[Docket No. 96-CE-72-AD]

Airworthiness Directives; All Models of The New Piper Aircraft, Inc. (Formerly Piper Aircraft Corporation) Airplanes Equipped With Wing Lift Struts

ACTION: Notice of proposed rulemaking (NPRM).

Appendix to Docket No. 96-CE-72-AD—Procedures and Requirements for Ultrasonic Inspection of Piper Wing Lift Struts

Figure 1

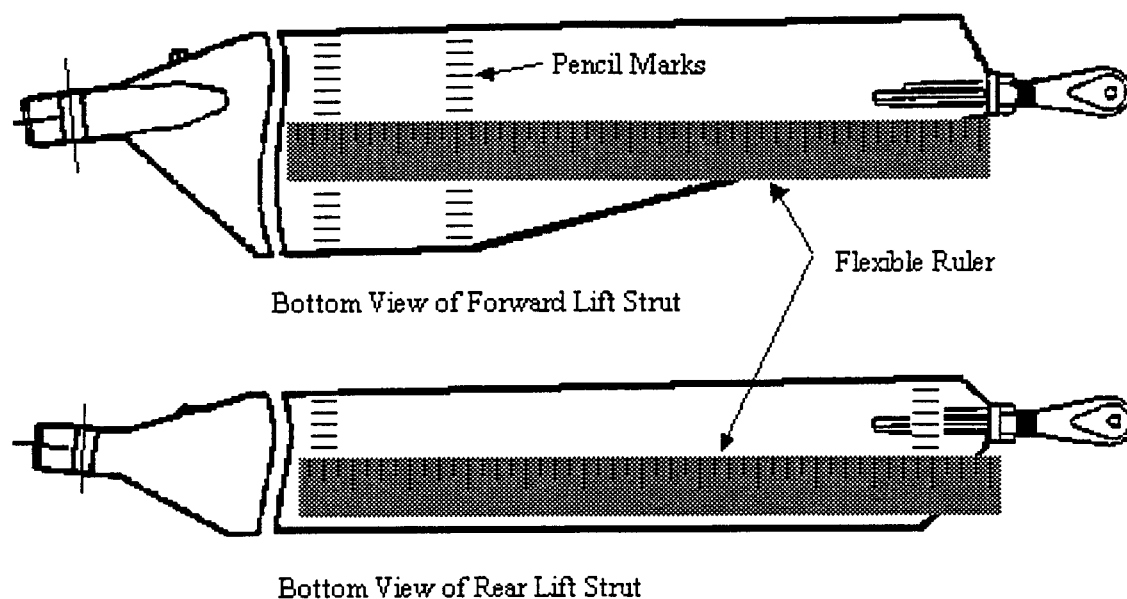
2. Using a flexible ruler, draw a 1/4-inch grid on the surface of the first 11 inches from the lower end of the strut as shown in Piper Service Bulletin No. 528D or 910A, as applicable. This can be done using a soft (#2) pencil and should be done on both faces of the strut. As an alternative to drawing a complete grid, make two rows of marks spaced every 1/4 inch across the width of the strut. One row of marks should be about 11 inches from the lower end of the strut, and the second row should be several inches away where the strut starts to narrow. Lay the flexible ruler between respective tick marks of the two rows and use tape or a rubber band to keep the ruler in place. See Figure 1.
